# Access Compliance Report Public Rights-of-Way (Curb Ramps)

Main Street: ANTIGUA\_ST Cross Street: BIENVILLE\_AVE Location: NE

ADA ID: RPAT211118111739 Ramp Type: Type 4 - Parallel Initial Pass/Fail: Pass Overall Compliance: No Severity Score: 5

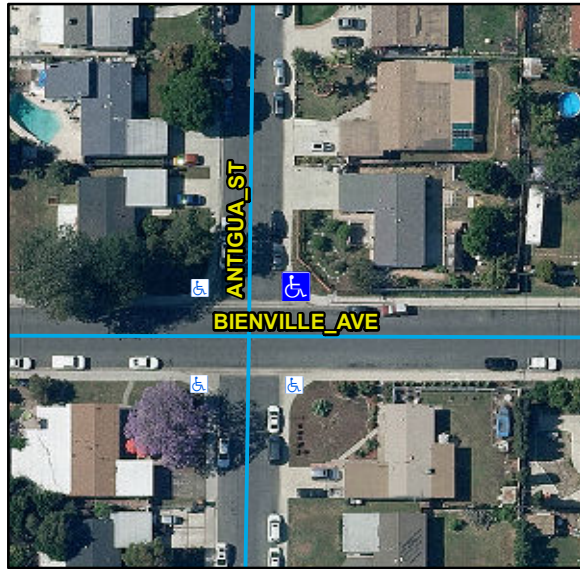
| Compliance | Description                   | Data       | Compliance | Description                   | Data   |
|------------|-------------------------------|------------|------------|-------------------------------|--------|
| No         | Gutter Run Slope (%)          | 5.2        |            | Road Cross Slope (%)          | 3.1    |

Remove & Replace Gutter.

R304.5.4, STD 1115
